INFORMATION SUBMITTED IN ADDITION TO THAT  
PROVIDED IN CONSUMERS POWER COMPANY SUBMITTALS  
OF MARCH 26, 1976 AND APRIL 5, 1976

1. The response to Question 6 of the March 26, 1976 letter indicated that procedures and/or design changes are presently under development to preclude the "undesirable function" failure of the mini-flow valves (CV-3027 and CV-3056) and that a response would be submitted at a later date. Circuitry changes have been initiated and will be completed prior to start-up to insure that a single failure will not cause a mini-flow valve to shut during the short-term cooling phase and also to insure that a single failure will not preclude the shutting of at least one mini-flow valve during the long-term cooling phase.

# CV-3027, CV-3056 PROPOSED MODIFICATION

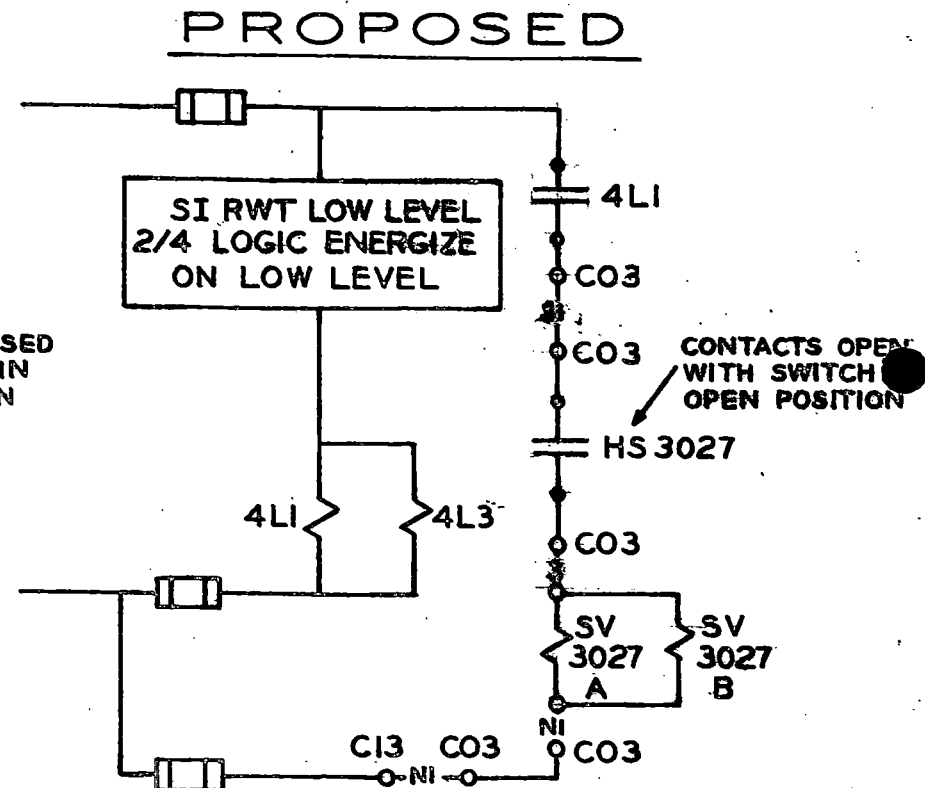
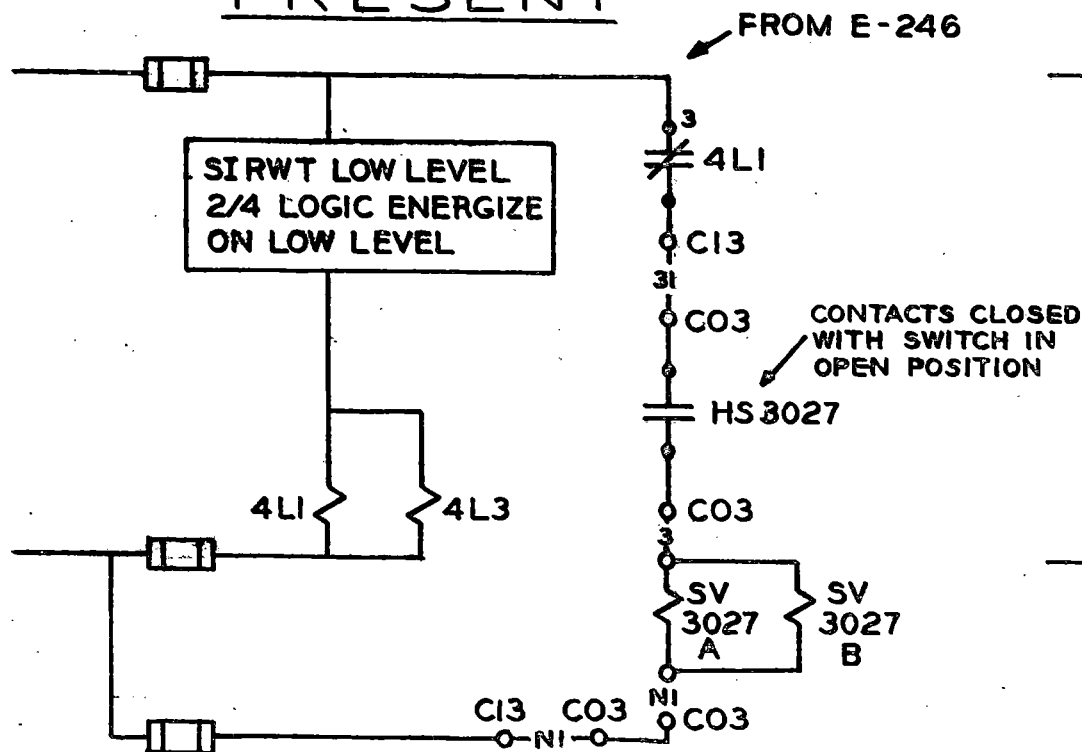
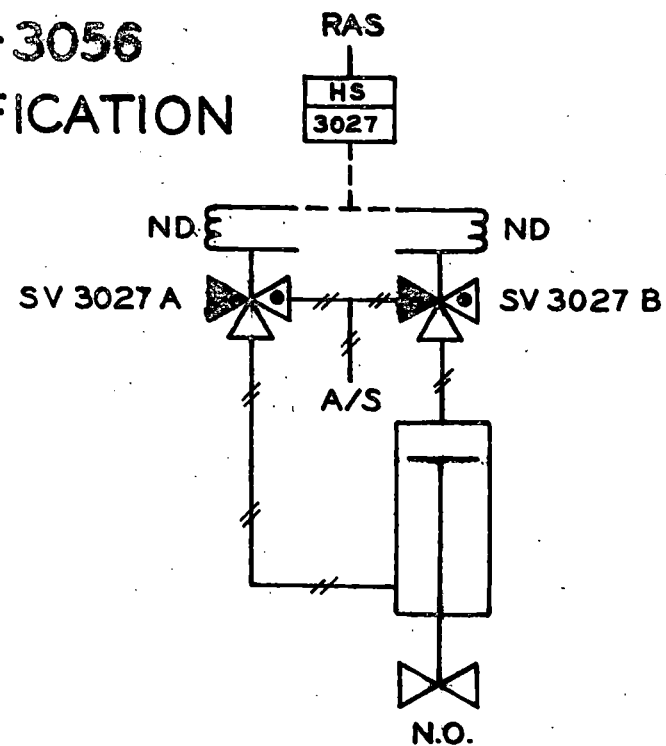
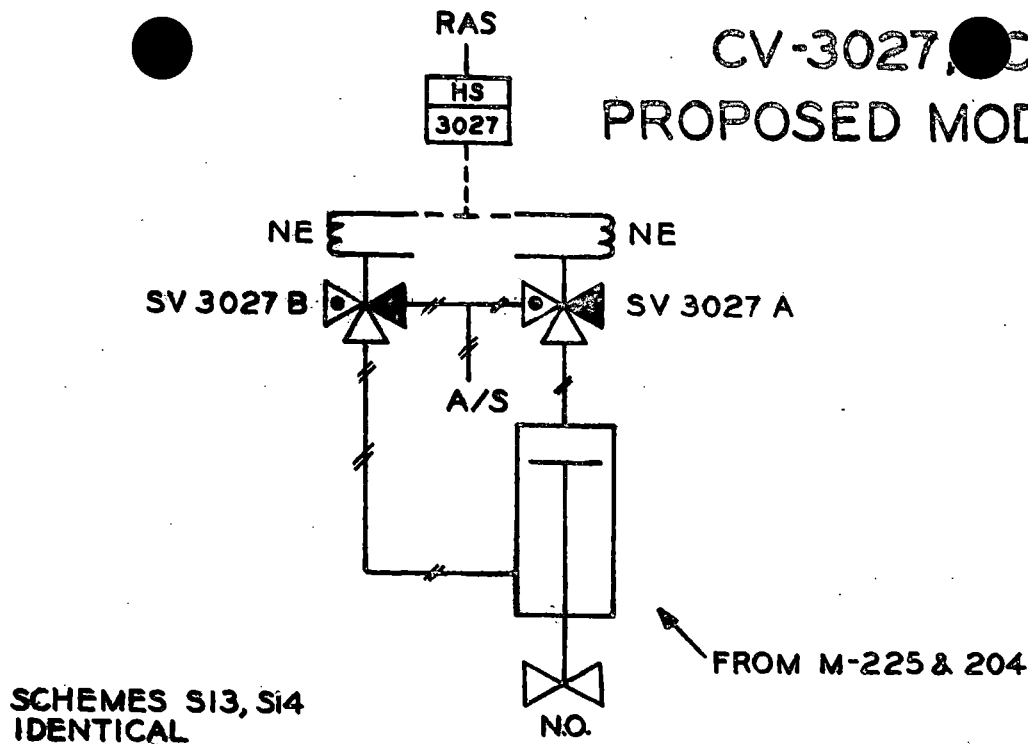
A stick diagram of the valve operator and solenoid valve arrangement is shown on the following figure. This stick diagram provides a good representation of how the valve is actuated. On the same diagram the existing electrical scheme is also shown. As can be seen from that scheme, a single electrical failure (closing of the contacts of HS-3027 or HS-3056) would cause the appropriate valve to go closed as well as any failure which causes the de-energization of both solenoids of each valve.

The same figure shows a stick diagram of the proposed modification to the solenoid valves and a proposed circuit modification. The result of these proposed modifications is that on a loss of electrical power the solenoid

valves for 3027 and 3056 are powered from different d-c buses resulting in the valve failing open. The modified circuit eliminates any electrical single failure which will cause the valve to fail shut. The two valves in series and their separate circuits provide protection against a postulated single failure causing both valves to remain open and thus the mini-flow line not being isolated during the recirculation phase.

The rearrangement of this circuit now requires that operator action be taken to close the mini-flow valves prior to initiation of the recirculation phase (approximately 30 minutes after the LOCA event). In addition, operator action to close these valves is not desirable until the primary coolant system pressure is decreased below the discharge head capability of both the high- and low-pressure safety injection pumps. The closure of the contacts associated with this hand switch in conjunction with a low level in the SIRW tank will initiate mini-flow valve closure. Thus, the closure of the hand switch contacts in conjunction with a nonvalid low level SIRW tank signal could cause the mini-flow valves to go closed prematurely. Thus, we will include in the appropriate operating procedures a requirement that the hand switch associated with the mini-flow valves be positioned such that the mini-flow valves will close automatically on a low level in the SIRW tank after the primary coolant system pressure has decreased to a value below the shutoff discharge pressure of the high-pressure and low-pressure safety injection pumps and prior to SIRW tank low level.
